# **Jemena Gas Networks (NSW) Ltd**

## **Response to the AER's draft decision and revised proposal**

### **Appendix 4.3 - Network projects - response to the draft decision**

27 February 2015

**Figure 2–4: Sutherland 210 kPa network simulation without and with potential Woollooware CDP implementation for winter 2017.**

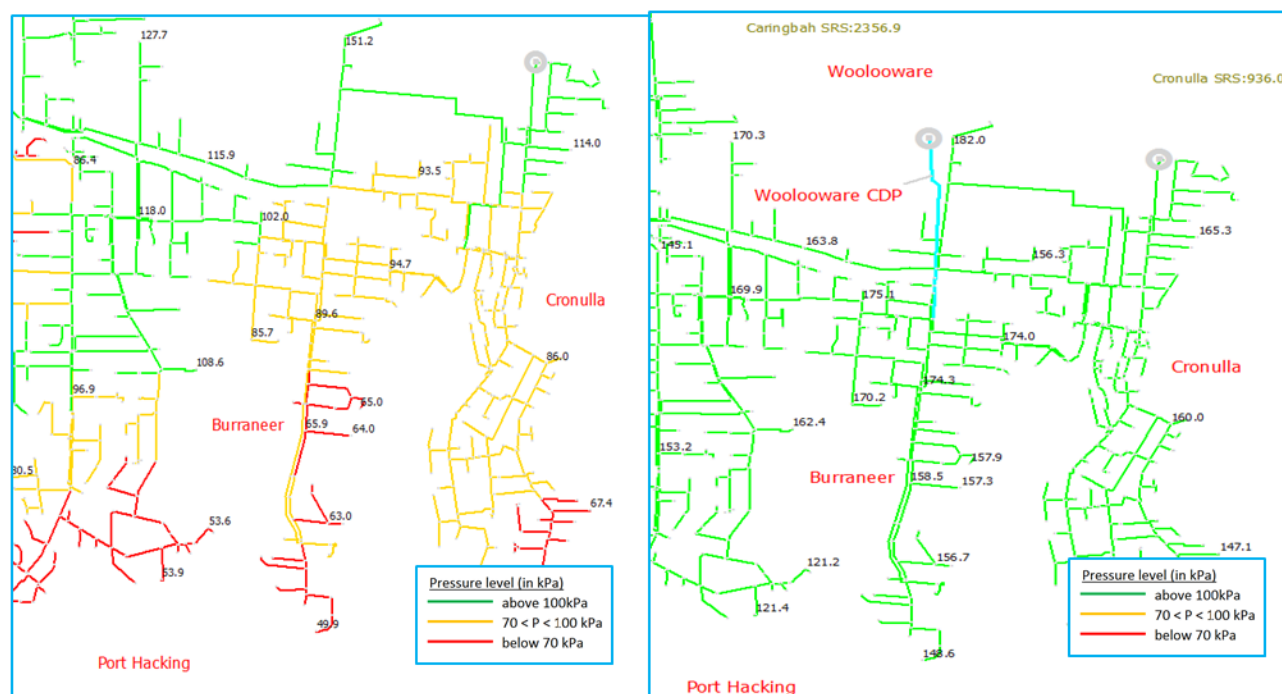
*Woollooware Rd upgrade (JGN Project ID 203, cost \$1.2m) is scheduled for completion in 2017 yet projected terminal pressures for winter of 2017 are projected on the basis of 3% per annum growth to be 137 kPa, comfortably in excess of the minimum desirable pressure for the 210 kPa network.*

*There is nothing to suggest the network pressure will fall below the 70 kPa minimum desirable level during the access arrangement period. Accordingly, in my opinion this item of Capex is not justified.<sup>4</sup>*

11. Sleeman Consulting stated that the pressures in the information supplied did not indicate any terminal pressures below the critical level of 70 kPa. Recent modelling based on the 2014 winter data shows that the forecast pressure for the Burraneer Bay area is below the 70 kPa minimum in winter 2017, as shown in Figure 2–4. Without the enhancement, there is a risk of loss of supply to more than 600 customers in winter 2017. (The modelling of the reinforcement uses the route of the alternative option.)
12. It should be noted that the nature of the mains design in this area is very sensitive to any changes in load. This is due to the long lengths of small bore pipe laid in the 1960s to supply the ‘finger’ peninsulas in the Sutherland Shire. This project provides a more robust backbone, reducing that sensitivity and providing the required capacity and a higher level of supply security.

**Figure 2–6: Scope for Hoxton Park CDP (Yarrawa Street)**

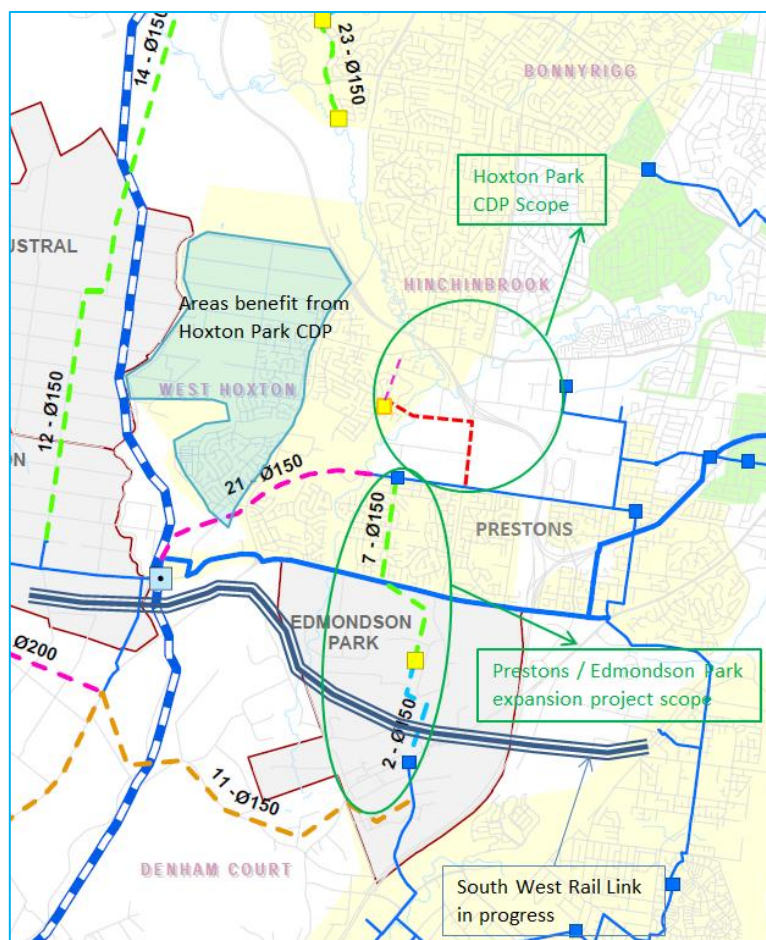
*Hoxton Park, Yarrawa Street, expansion (JGN Project ID 204, cost \$3.1m) is scheduled for completion in 2020 to meet demand growth over the next 20-30 years. Given the recent, changed nature of demand growth (see paragraph 2.11) a need for the project has not presently been demonstrated. I consider it would be premature to commit to this project now.*

*The project also interacts with, and will not be required, if network support is instead provided by means of a Cocon installation that is separately proposed (as a market expansion project)alt (sic) for the western end of Kurrajong Road. Provision of network support in this alternative way not only overcomes the need for the Yarrawa Street expansion, it provides capacity to meet possible Carnes Hill expansion at the Ingham site.*

Accordingly, in my opinion this item of Capex is not justified.<sup>5</sup>

16. Sleeman Consulting rejects this project on the basis that the capacity will not be required because the demand has not yet occurred or is unlikely to occur. Table 2–1 provides the basis for the demand projection and clearly indicates that the demand is occurring, if anything, ahead of schedule originally anticipated.
17. Sleeman Consulting also rejects this project on the basis that an alternative project (Prestons / Edmondson Park CDP – Kookaburra Road C414-219) will provide the required capacity. Figure 2–6 shows the relative locations of and areas to be supplied by the two projects.

**Figure 2–10: Sydney 7 kPa network simulation without and with Haymarket CDP**

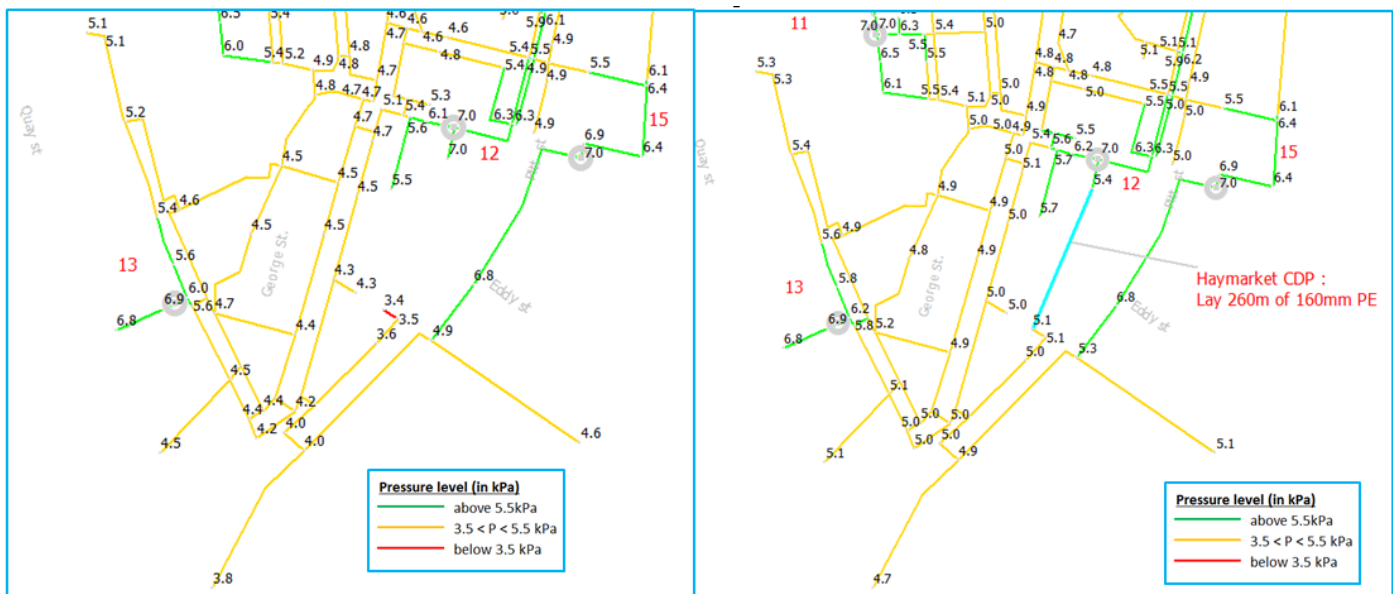
*Haymarket, Parker Street upgrade (JGN Project ID 212, cost \$0.4m) is scheduled for completion in 2019 yet minimum desirable pressures for the 7 kPa network (namely 3.5 kPa<sup>11</sup>) are comfortably exceeded on the basis of an assumed 3% per annum load growth. I note also that the assumed 3% per annum load growth may in any case be high.*

*There is nothing to suggest the network pressure will fall below the 3.5 kPa minimum desirable level during the access arrangement period. Accordingly, in my opinion this item of Capex is not justified.<sup>6</sup>*

22. Sleeman Consulting correctly states that modelling indicates that the pressure in the area remains above 3.5 kPa for the period until beyond 2020. Updated modelling based upon 2014 winter gauging confirms this outcome, with predicted minimum terminal pressures at 3.8 kPa. However, the nature of the network design in this area (7 kPa serving a mixture of commercial and high density residential) means that network performance is very sensitive to any changes in load, either from an existing customer or new customers.

23. This sensitivity means that the addition of a new commercial or residential load (or reasonable increase in load for an existing customer), above that provided for in general growth forecasts, in Pitt Street, George Street or Rawson Place will result in pressure reducing to less than 3.4 kPa which is at the minimum acceptable for the 7 kPa network.<sup>7</sup> Construction conditions in the CBD require careful planning, approvals and generally take considerable time. Pre-emptive laying of this mains extension will provide JGN with the ability to meet customer expectations and provide new connections that may otherwise be lost due to the delays generally experienced in the CBD for connections. This area of the CBD continues to be developed.

24. Figure 2–10 outlines the capacity modelling for this project with the minimum terminal pressure increasing from 3.8 kPa to 4.7 kPa, ensuring the ability to meet potential customer expectations.

**Figure 2–11: Modified scope of work for Kincumber CDP**

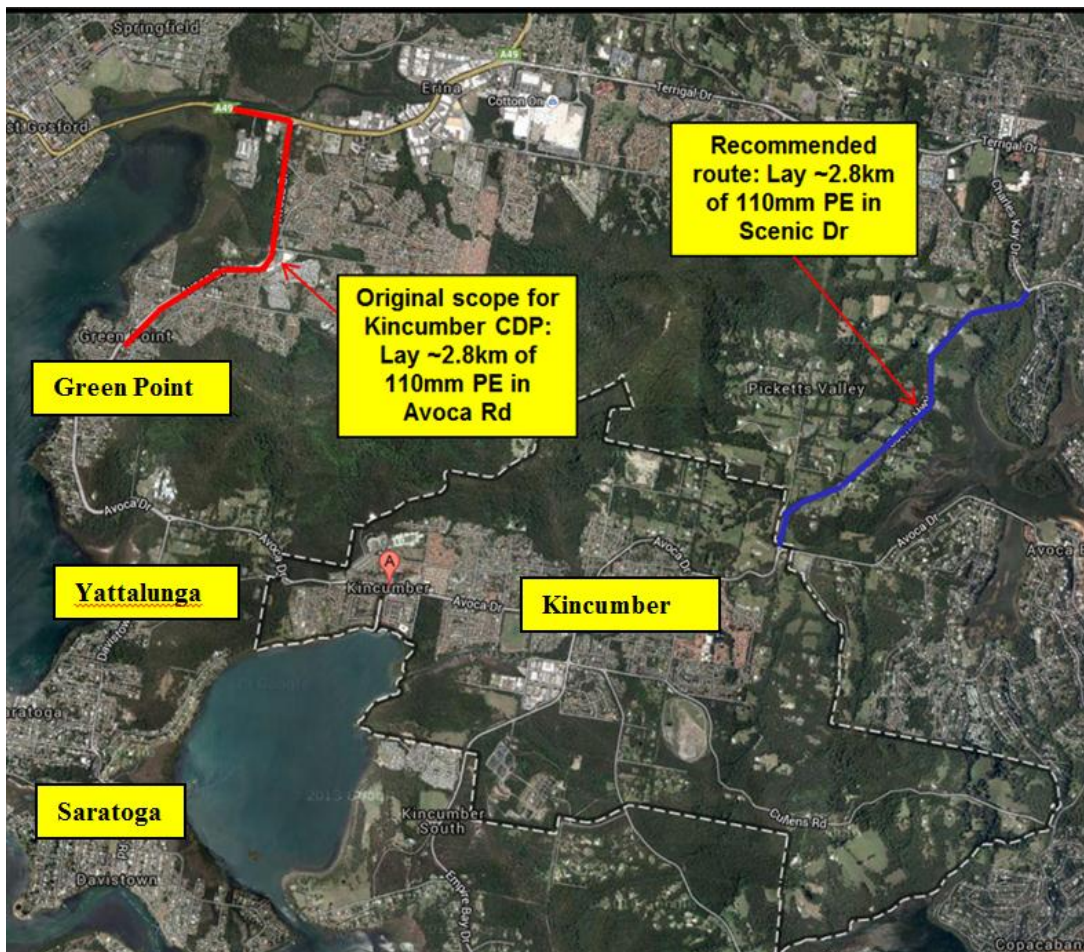
*Kincumber capacity expansion (JGN Project ID 213, cost \$1.8m) is scheduled for completion in 2020. The purpose of the project is to avoid possible low pressure within the 210 kPa network at Kincumber, but the need for the project was based upon 2013 gas demand forecasts. System pressure records for recent years<sup>12</sup> have not indicated cause for concern and, with regard for the observations of paragraph 2.11, future demand growth is likely to be less than was forecast by JGN in 2013.*

*There is nothing to suggest the network pressure will fall below the 70 kPa minimum desirable level for the 210 kPa network during the access arrangement period. Accordingly, in my opinion this item of Capex is not justified.<sup>8</sup>*

26. JGN has done further modelling and analysis of this project since the initial proposal was submitted. This has led to an alternative design being recommended, being the installation of 2,800 metres of 110mm polyethylene in Scenic Drive. This alternative is estimated to cost the same as the original proposal, however, it will provide a higher level of security of supply as it does not parallel the existing infrastructure. The updated scope is shown in Figure 2–11.

Figure 2–16: Sydney 7 kPa network simulation without and with the Kent – Druitt Streets CDP

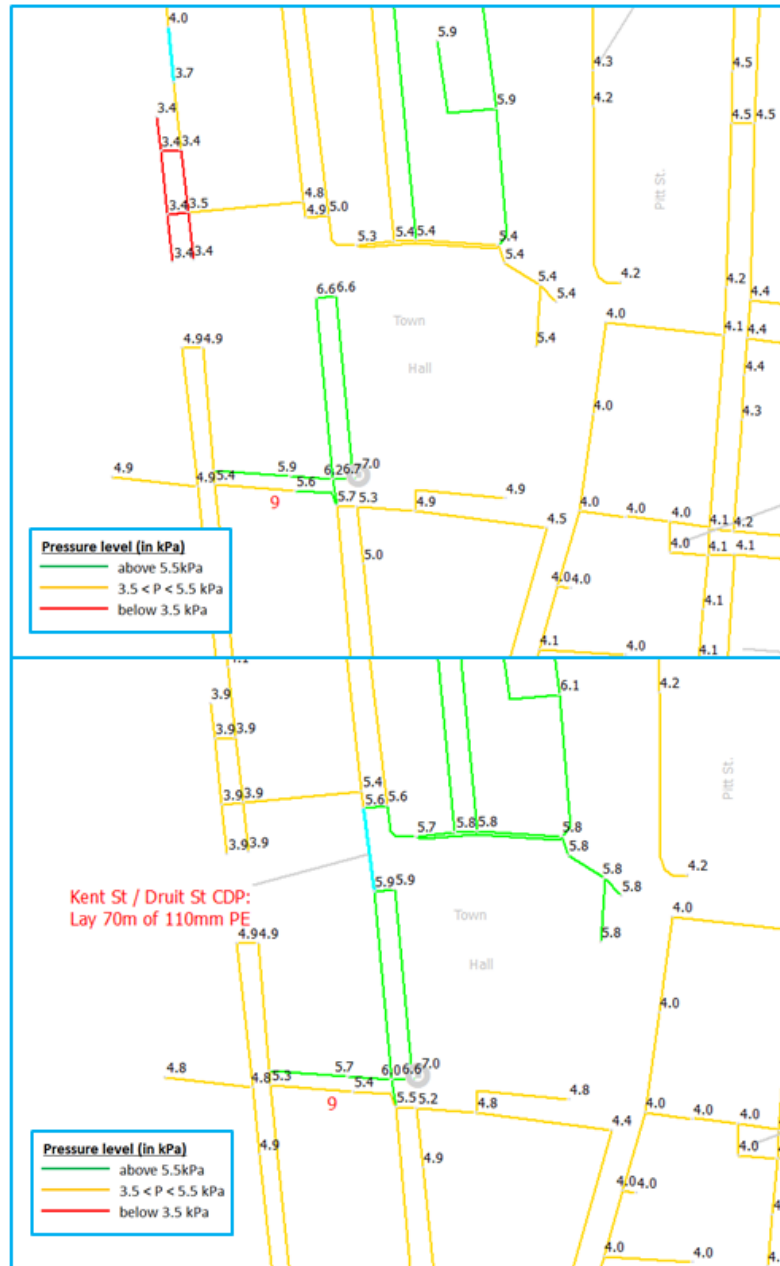
*Sydney, Kent - Druitt Streets (JGN Project ID 222, cost \$0.2m) is scheduled for completion in 2019 yet gas pressures are presently, and are projected to continue to be, comfortably above the desirable minimum for the 7 kPa network (that is, 3.5 kPa). Accordingly, in my opinion this item of Capex is not justified.<sup>9</sup>*

31. Sleeman Consulting correctly states that modelling indicates that the pressure in the area remains above 3.5 kPa for the period until beyond 2020. Updated modelling based upon 2014 winter gauging confirms this outcome, with predicted minimum terminal pressures at 3.8 kPa. However, the nature of the network design in this area (7 kPa serving a mixture of commercial and high density residential) means that network performance is very sensitive to any changes in load, either from an existing customer or new customers.

32. This sensitivity means that the addition of a new commercial or residential load (or reasonable increase in load for an existing customer), above that provided for in general growth forecasts, in Sussex Street will result in pressure reducing to less than 3.4 kPa which is at the minimum acceptable for the 7kPa network.<sup>10</sup> Construction conditions in the CBD require careful planning, approvals and generally take considerable time. Pre-emptive laying of this mains extension will provide JGN with the ability to meet customer expectations and provide new connections that may have otherwise been lost due to the delays generally experienced in the CBD for connections. This area of the CBD continues to be developed.

33. Figure 2–16 outlines the capacity modelling for this project with the minimum terminal pressure increasing from 3.8 kPa to 4.7 kPa, ensuring the ability to meet potential customer expectations.

**Figure 2–23: Bradbury stage 1 and stage 2 CDPs to supply Mount Gilead new estate development**

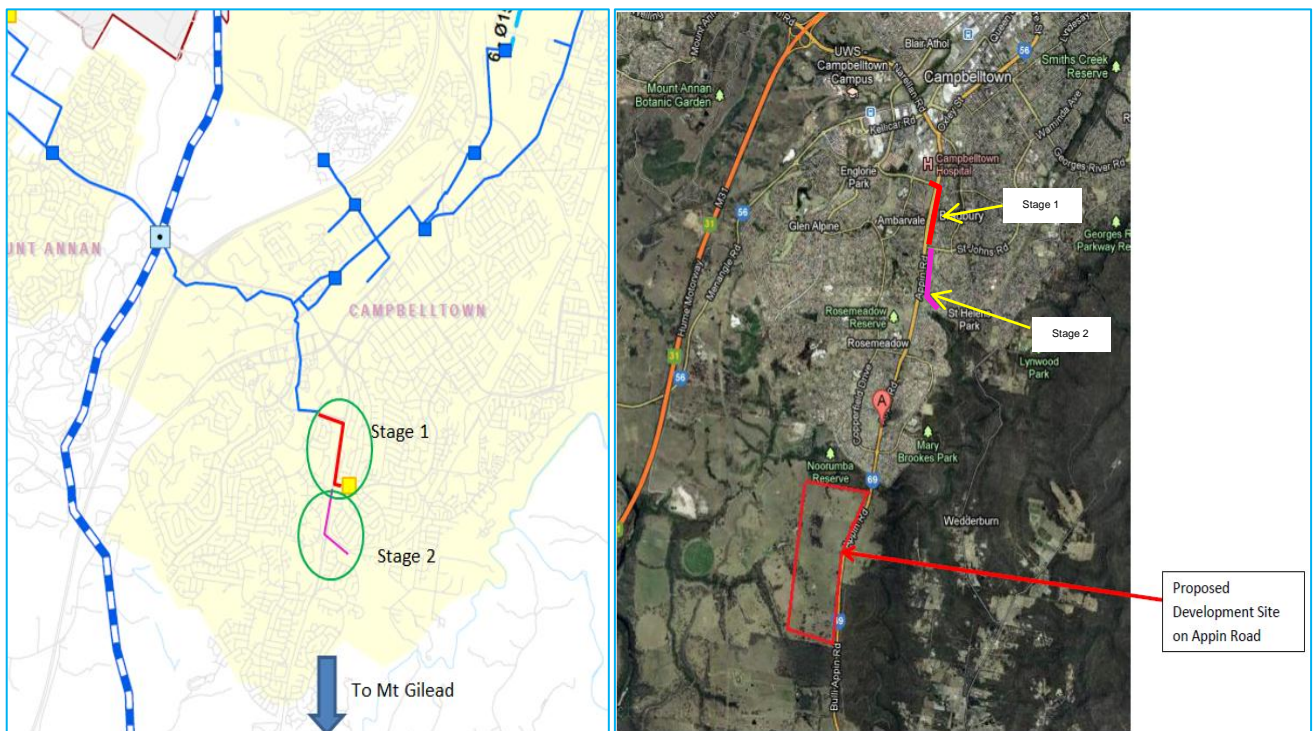
*Bradbury stage 2 expansion (JGN Project ID 233, cost \$0.3m in present period) is scheduled for completion in 2021. This project should be delayed since the Bradbury Stage 1 project (JGN Project ID 207, cost \$1.4m) is itself not scheduled for completion until 2021. Accordingly, in my opinion this item of Capex is not justified.<sup>14</sup>*

RY20, with only project close-out in RY21. Stage 2 CDP is an integral continuation of Bradbury stage 1. Stage 2 is scheduled for winter 2021 completion (refer to Figure 2–20 and Figure 2–23).

51. Funding for Bradbury stage 2 is still required in the 2015-20 AA period.
52. Figure 2–23 shows the location of the Bradbury stage 1 and stage 2 CDPs

**Figure 2–26: Hurstville 210 kPa network simulation without and with the Rockdale CDP**

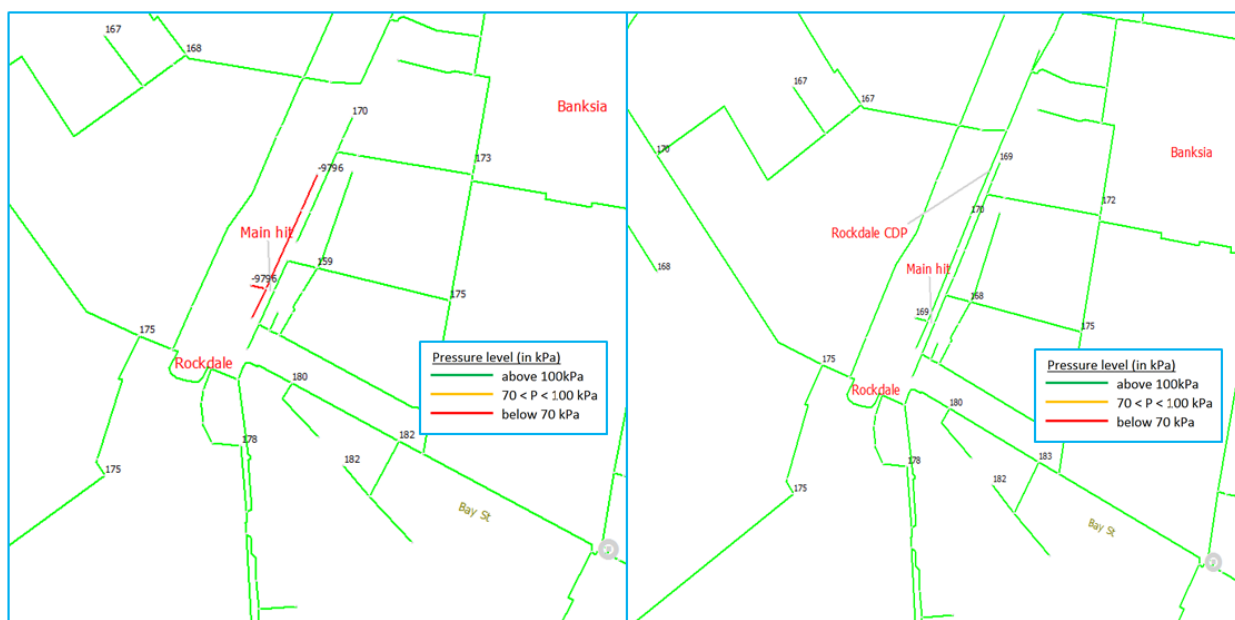
*Rockdale reinforcement work (JGN Project ID 237, cost \$0.3m) is scheduled for completion in 2020 yet terminal network pressures are presently well above the desirable minimum for the 210 kPa network.*

*There is nothing to suggest the network pressure will fall below the 70 kPa minimum desirable level for the 210 kPa network during the access arrangement period. Accordingly, in my opinion this item of Capex is not justified.<sup>15</sup>*

57. Sleeman Consulting has correctly identified that there is sufficient capacity in this area under normal operating conditions. However, this project has been incorrectly categorised as a capacity improvement project in the Opportunity Brief. The key driver of the project is to provide security of supply to a number of commercial customers. There is only a single direction main supplying 27 active commercial customers, six which each have a load of more than 500GJ/yr. All 27 would lose supply in the event of damage to the single feeder main. These customers are mostly on the Princess Highway. The location of these customers in a congested area means that any damage to the feeder main would be a complex repair activity, potentially leaving the customers without gas for up to two days. Implementation of this project will enable backflow for security of supply. Figure 2–26 outlines the effect of damage to the feeder main and the benefit of an interconnection.

58. Additionally, this project will provide a better design for managing incident responses. The additional high risk valve included in the project will limit the number of lost customers during any incident.
